HISTORIC AND DESIGN REVIEW COMMISSION

May 07, 2025

HDRC CASE NO: 2025-101
ADDRESS: 626 NOLAN ST
622 NOLAN ST
LEGAL DESCRIPTION: NCB 561 BLK 1 LOT E 10.52 FT OF 5 & W 54.14 FT OF 6
NCB 561 BLK 1 LOT W IRR 49.25 FT OF 5
ZONING: R-6, H
CITY COUNCIL DIST.: 2
DISTRICT: Dignowity Hill Historic District
APPLICANT: Adan Ochoa/AO Design, LLC
OWNER: DAWSON NOLAN DEVELOPMENT LLC
TYPE OF WORK: Construction of five, 2-story residential structures
APPLICATION RECEIVED: April 18, 2025
60-DAY REVIEW: June 17, 2025
CASE MANAGER: Edward Hall

The applicant is requesting conceptual approval to construct five, 2-story residential structures at 622 and 626 Nolan Street, located within the Dignowity Hill Historic District. Three structures will be constructed on the lot addressed as 622 Nolan and two structures will be constructed to the rear of the historic structure at 626 Nolan.

3b SCHEMATIC SITE PLAN
Scale: 1/16" = 1'-0"

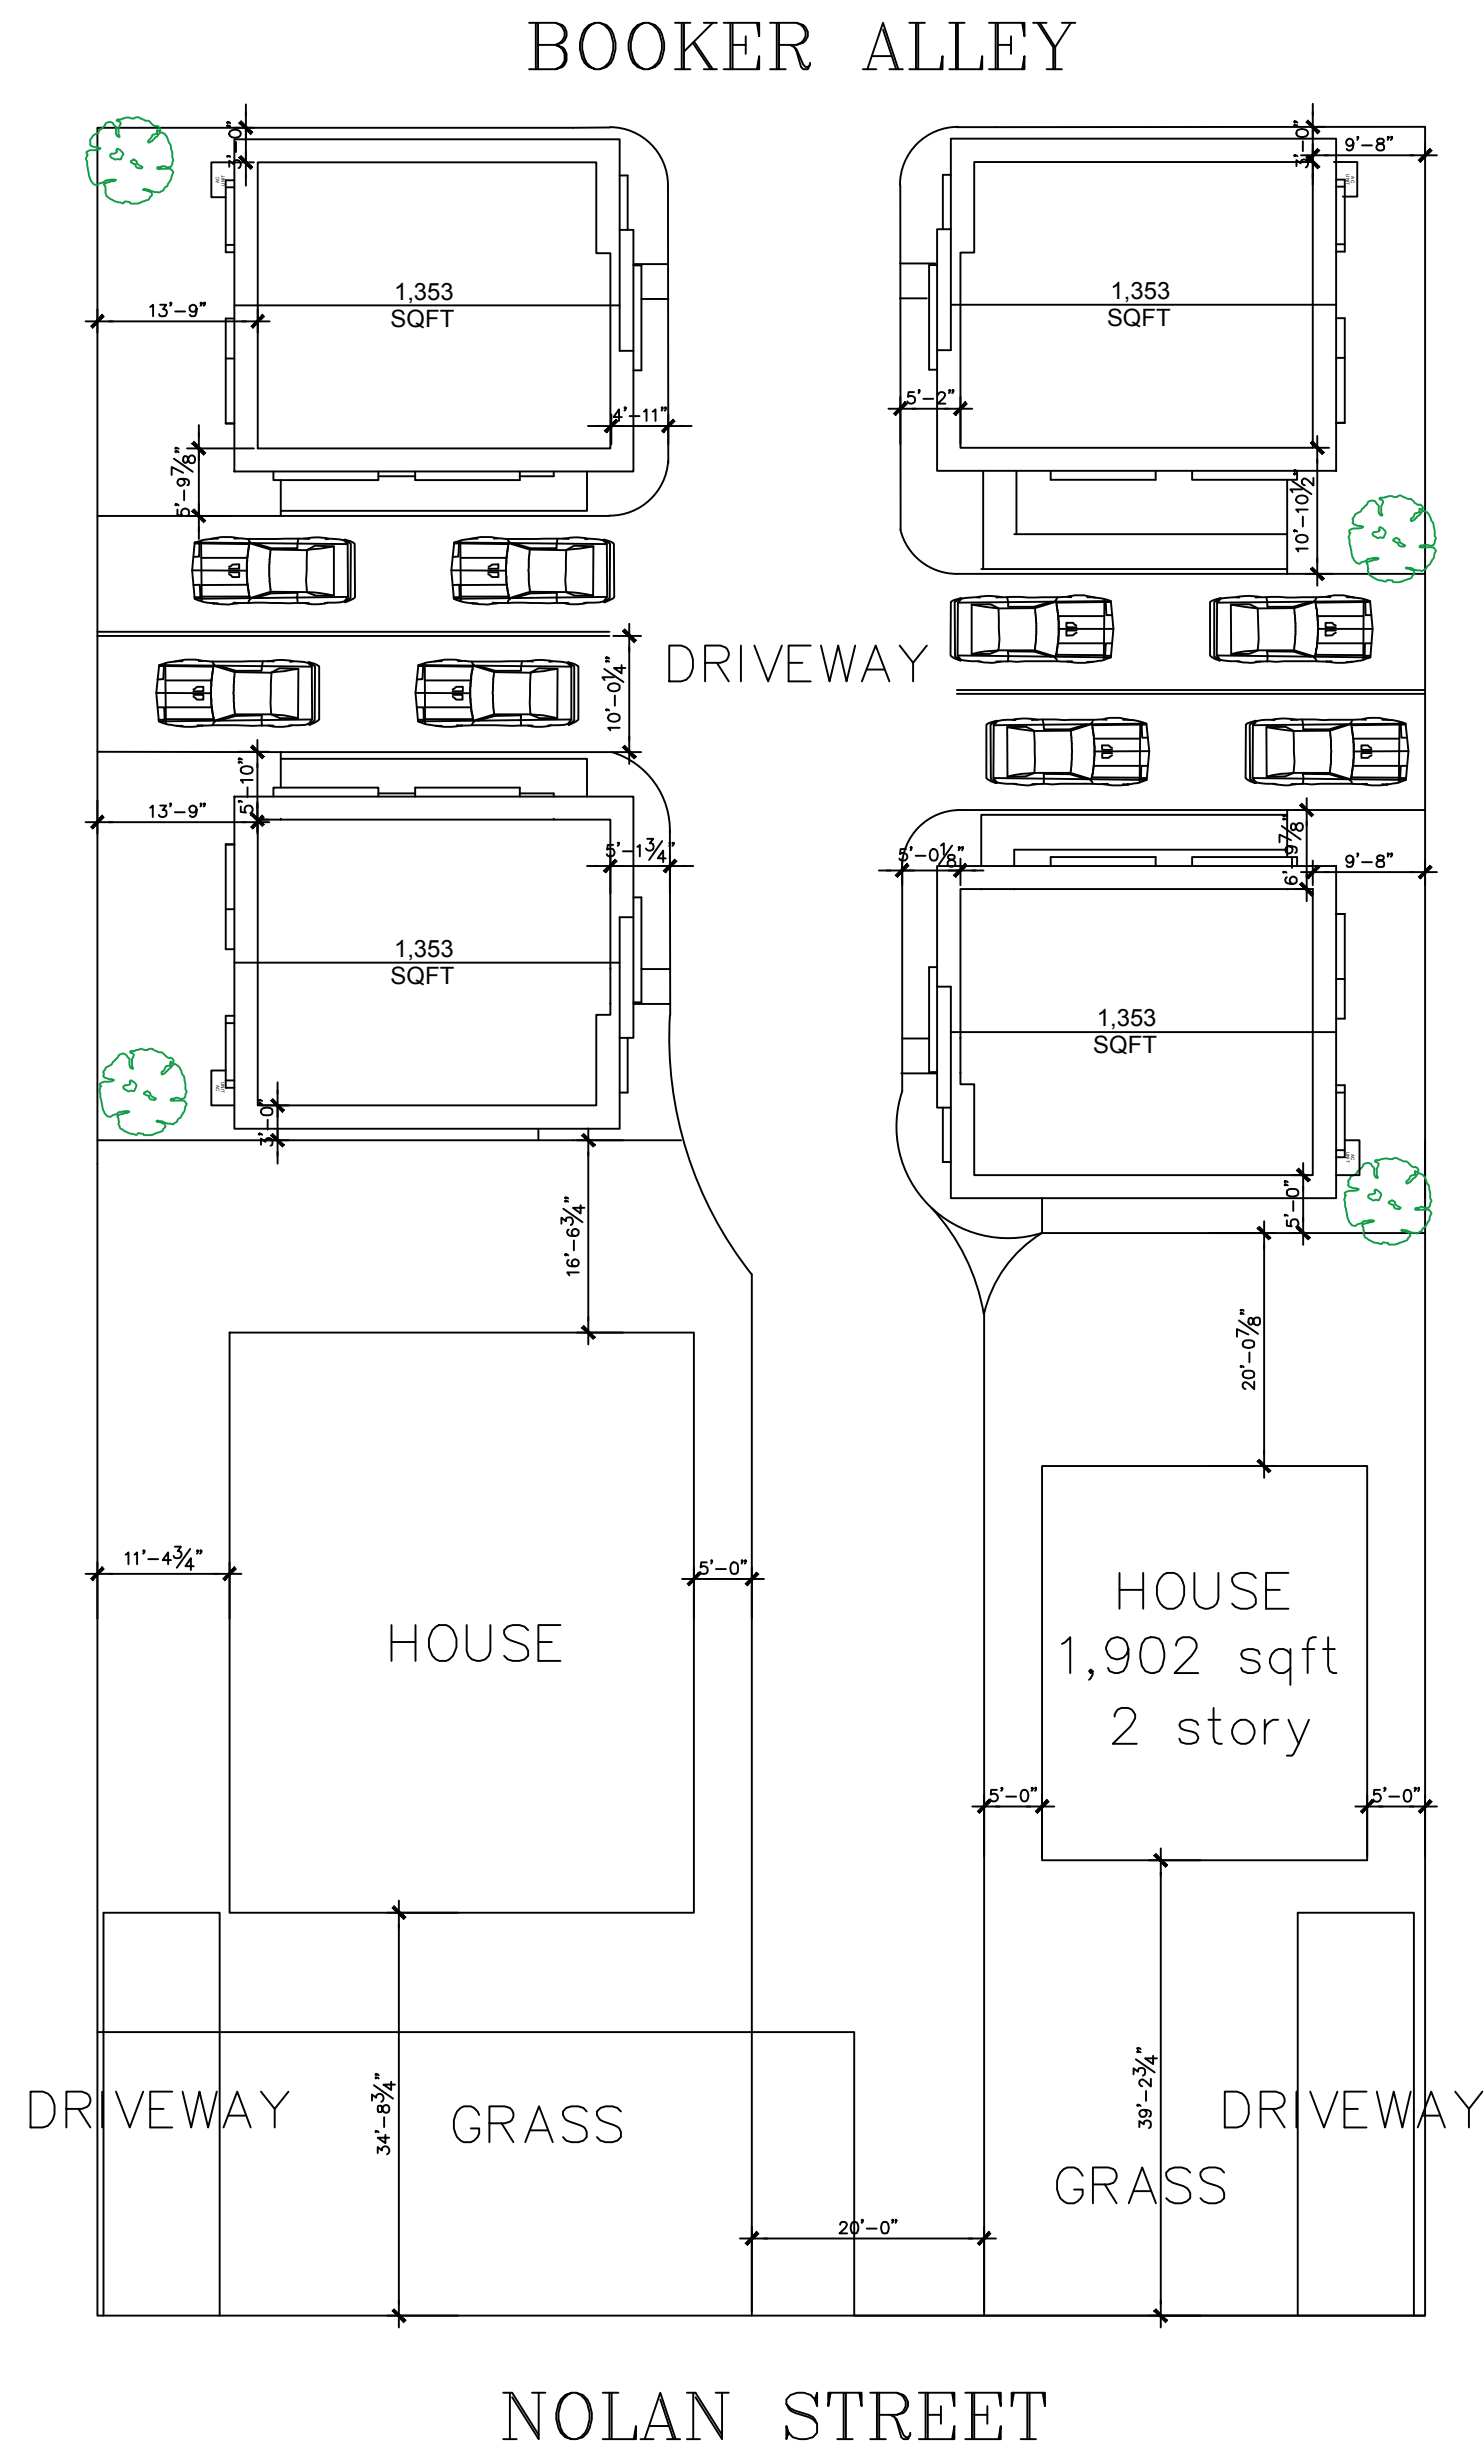
- e. **SETBACKS** – According to the Guidelines for New Construction, the front facades of new buildings are to align with front facades of adjacent buildings where a consistent setback has been established along the street frontage. Additionally, the orientation of new construction should be consistent with the historic examples found on the block. The applicant has provided a setback diagram using an aerial photo that notes a setback for the 2-story house fronting Nolan. Per the diagram, this setback appears to be greater than the historic setbacks on the block. Staff finds this to be appropriate and consistent with the Guidelines. When returning to the Commission for final approval, staff finds that a site plan noting the proposed setback in relationship to others on the block should be submitted.

- s. DRIVEWAY – Each existing lot currently features a driveway, and both meet along the dividing property lines of each lot. The applicant has proposed to install one central driveway to provide vehicular access into the lot to feature a total width of twenty-five (25) feet, and two install an addition driveway on each lot provide parking for the front two structures. The Guidelines for Site Elements 5.A.i. notes that new driveway should incorporate a similar driveway configuration as to what is found historically. Typically, historic driveways are no wider than ten (10) feet in width. Staff finds that the proposed center drive should be no wider than ten (10) feet. If additional width is required by code to accommodate emergency vehicles, it should be accomplished through the use of materials that also serve as landscaping elements, such as grasscrete. Regarding the two additional driveways, in the sideyard of both lots, staff finds that both should be eliminated as they would result in front yard parking.

- t. PARKING – The applicant has proposed on site parking for each of the rear structures. The proposed parking is located between each of the four rear structures. Generally, staff finds that all parking should be located no further forward than the rear yard space behind the front two structures.

- i. That a site plan noting the proposed setback in relationship to others on the block be submitted for review and approval when returning to the Commission for final approval, as noted in finding e.

- ix. That the applicant reduce the width of the proposed central driveway to no more than ten (10) feet in width. If additional width is required by code to accommodate emergency vehicles, it should be accomplished through the use of materials that also serve as landscaping elements, such as grasscrete. Additionally, staff recommends that the two proposed side driveways be eliminated as they introduce front yard parking conditions.

3 South Elevation
Scale: 1/4" = 1'-0"

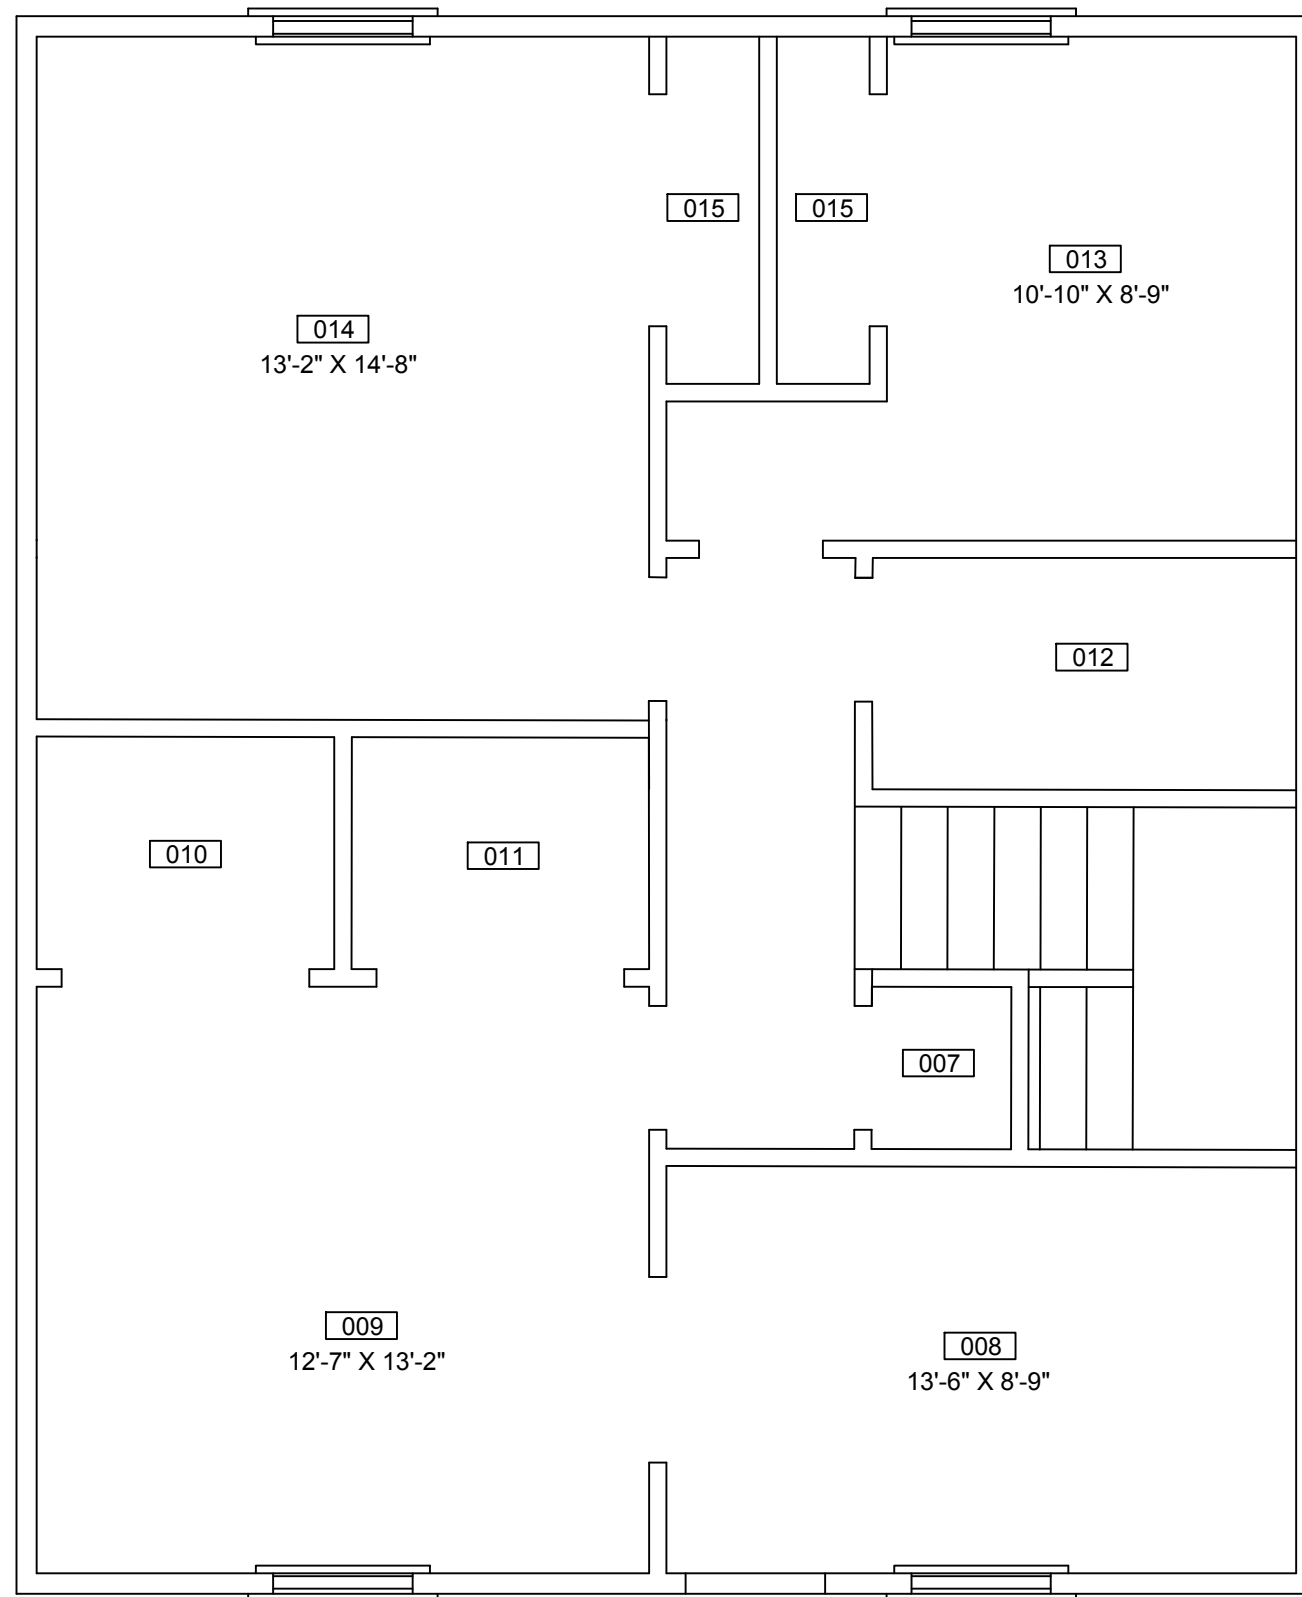
- m. FENESTRATION PROFILE (Nolan Structure) – The applicant has provided a front elevation that notes the proposed fenestration pattern. Generally, staff finds the proposed window sizes to be consistent with those found historically within the district.

- o. PORCH DESIGN (Nolan Structure) – The applicant has proposed a porch design that is representative of four-square Craftsman structures. Generally, staff finds the proposed porch massing to be appropriate; however, staff finds that columns should be redesigned to be representative of the style and massing of the proposed porch.

- q. ARCHITECTURAL DETAILS (Nolan Structure) – Generally, staff finds the proposed architectural details to be appropriate; however, as noted in the above findings, staff finds that the proposed porch columns should feature increased massing and a redesign that related them to those found historically within the district. Additionally, staff finds that the dormer's windows should be reconfigured to better represent those found historically within the district.

- vii. That the front porch of the structure facing Nolan Street feature columns that respond to the structure's architectural design and that the rear structures feature a roof element at each porch, as noted in finding o and p.

ELEVATION (SCHEMATIC UNIT 1-4)

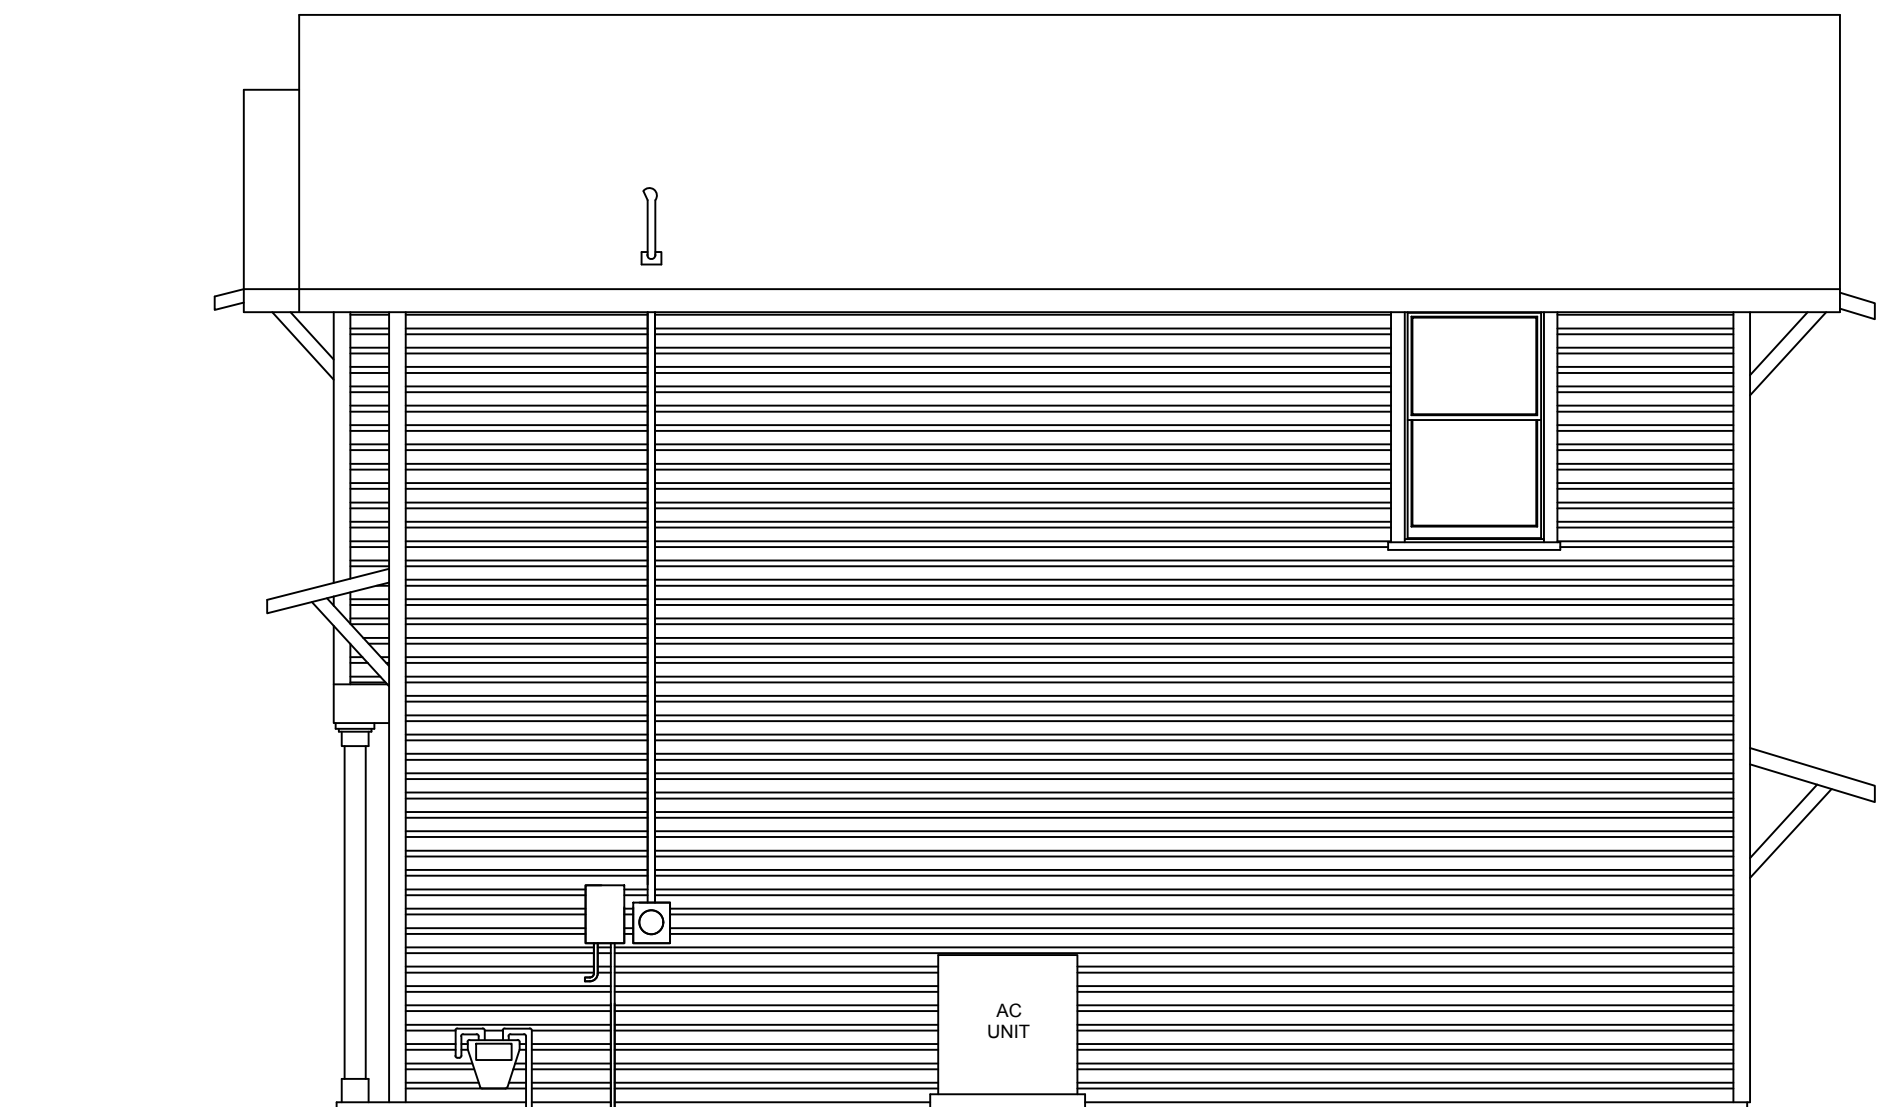
- n. FENESTRATION PROFILE (Rear Structures) – The applicant has provided elevations for the four rear structures. Generally, these each feature window sizes that are consistent with those found historically within the district; however, staff finds that fenestration should be added to each side façade. Additionally, staff finds that the applicant should consider centering the second story grouped windows beneath the gable.

- p. PORCH DESIGN (Rear Structures) – The applicant has proposed for the rear structures to feature a recessed porch with no distinctive roof elements. Typically, historic structures feature roof massing that is incorporated into the massing of the residential structure and that features an individual roof profile or roof element. Staff finds that additional architectural detailing should be added at the porch location.

- r. ARCHITECTURAL DETAILS (Rear Structures) – The applicant has proposed for the four rear structures to feature identical façade arrangement. Staff finds that the applicant should incorporate variations in to each structure's façade, including varying façade arrangements, material profiles, and fenestration profiles. Additionally, as noted in finding n, staff finds that additional fenestration should be added to side facades and that the applicant should consider centering the second story grouped windows beneath the gable.

- vi. That fenestration is added to each side façade of the four rear structures and that the applicant consider centering the second level windows beneath the front facing gable, as noted in finding n.

- viii. That the rear structure's feature various façade elements, fenestration profiles and material profiles to distinguish them as unique designs, as noted in finding q.
